DV-C600,

Ref: 112200-3

Service Tip and Troubleshooting:

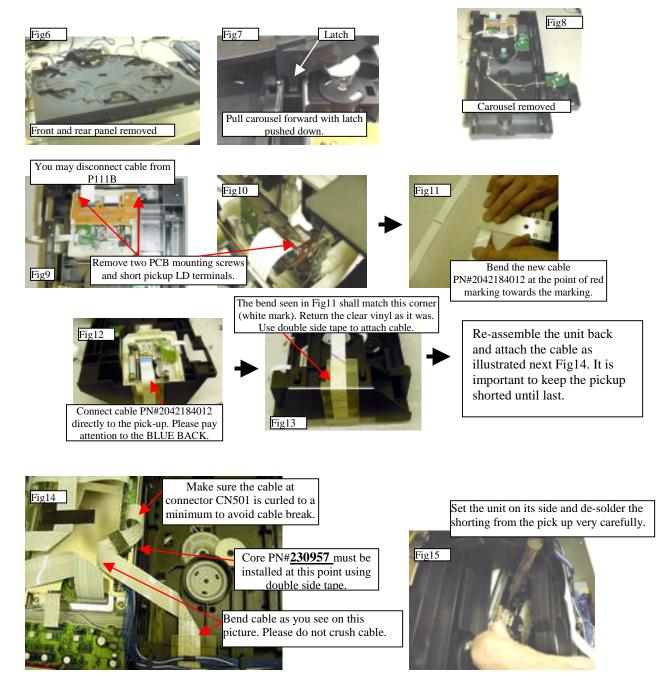
If the shorting PCB seen in Fig 3 is not in place, you will need to keep the DSP still connected to CN501 connector until pick-up shorting is done as seen on figure 10. Keep DSP attached to the frame with an electrical tape.

Check and verify procedure as given on page 43,44 of service manual. For disk to be recognized while carousel is rotating but fail to spin and focus is a result of missing LD ON. This happens when one of the connectors at any of the three points (Fig1 A, B and or Fig2 C) is lacking good contact to the ribbon.

Replace pickup connector cable. "Second time around".

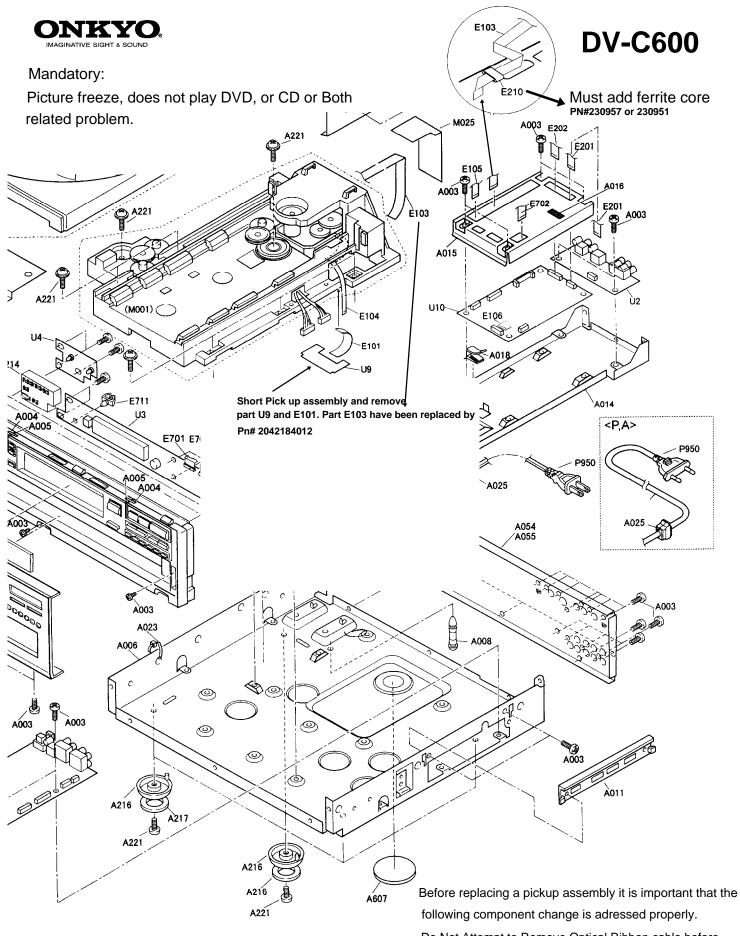
D: To help reduce the break up of the video signal, remount <u>CORE</u> <u>#230957</u>. The installation of this core should be as illustrated on Fig14.
